Access Compliance Report

Public Rights-of-Way

Intersection ID: 49297	Main Street: CAMPBELL_HALL_CT	Cross Street: CHAMBERLIN_RD	Location: NE
ADA ID: 2EF47BBBCAA5	Ramp Type: Perp	Initial Pass/Fail: Fail	Overall Compliance: No
		Severity Score: 12.5

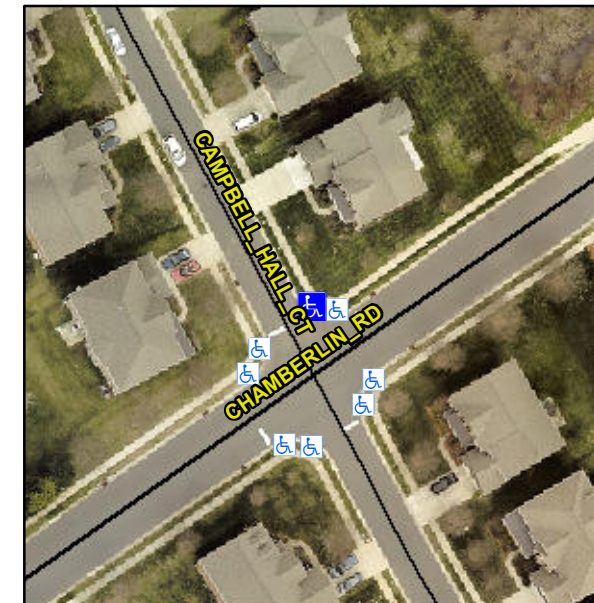
Not Found, R304.2.2

Compliance	Description	Data	Compliance	Description	Data
N/A	Ramp Length (in)	47.0	No	Ramp Slope (%)	10.0
Yes	Ramp Width (in)	48.0	Yes	Ramp XSlope (%)	1.3
N/A	Flare Type LT	N/A	N/A	Flare Type RT	N/A
N/A	Flare Slope LT (%)	N/A	N/A	Flare Slope RT (%)	N/A
N/A	Flare Traversable LT?	N/A	N/A	Flare Traversable RT?	N/A
N/A	Landing Length (in)	N/A	N/A	DWS Provided?	N/A
N/A	Landing Width (in)	N/A	N/A	DWS Contrast?	N/A
N/A	Landing Slope (%)	N/A	N/A	DWS Length (in)	N/A
N/A	Landing X Slope (%)	N/A	N/A	DWS Full Width?	N/A
N/A	Landing Curb? (Y/N)	N/A	N/A	DWS Offset (in)	N/A
N/A	Shared Landing?	N/A			
N/A	Gutter Ponding?	N/A	N/A	Gutter Slope (%)	N/A
N/A	Gutter Lip Ht (in)	N/A	N/A	Gutter X Slope (%)	N/A
N/A	Painted X Walk1?	No	N/A	Painted X Walk2?	N/A
	X Walk 1 Direction	To SW		X Walk 2 Direction	N/A
N/A	X Walk 1 Width (in)	N/A	N/A	X Walk 2 Width (in)	N/A
	X Walk 1 Slope (%)	0.1		X Walk 2 Slope (%)	N/A
	X Walk 1 X Slope (%)	1.2		X Walk 2 X Slope (%)	N/A

Remove & Replace Entire Ramp.
